PRODUCT UPDATE

- **CG03114** - 3 ft 18 AWG Outlet Saver Power Extension Cord (NEMA 5-15P to NEMA 5-15R)
- **CG03115** - 6 ft 18 AWG Outlet Saver Power Extension Cord (NEMA 5-15P to NEMA 5-15R)
- **CG03116** - 10 ft 18 AWG Outlet Saver Power Extension Cord (NEMA 5-15P to NEMA 5-15R)
- **CG03117** - 15 ft 18 AWG Outlet Saver Power Extension Cord (NEMA 5-15P to NEMA 5-15R)
- **CG53408** - 12 ft 18 AWG Outlet Saver Power Extension Cord (NEMA 5-15P to NEMA 5-15R)

MODEL COMPARISON

PREVIOUS VS. UPDATED DESIGN

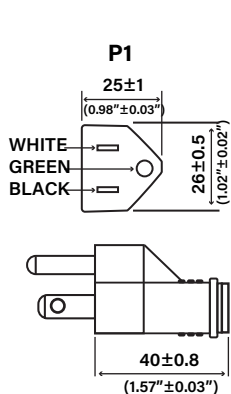
1. The NEMA 5-15P connector now features a minor visual update, with double lines around the pins.
2. The NEMA 5-15P connector dimensions have been adjusted from 40mm ± 0.8 mm x 26mm ± 0.5 mm x 25mm ± 1 mm (LxWxH) to 38mm ± 1 mm x 21mm ± 0.4 mm x 23.6mm ± 0.4 mm (LxWxH).
3. The temperature rating has been upgraded from 75°C to 105°C to comply with the latest UL and CUL standards.
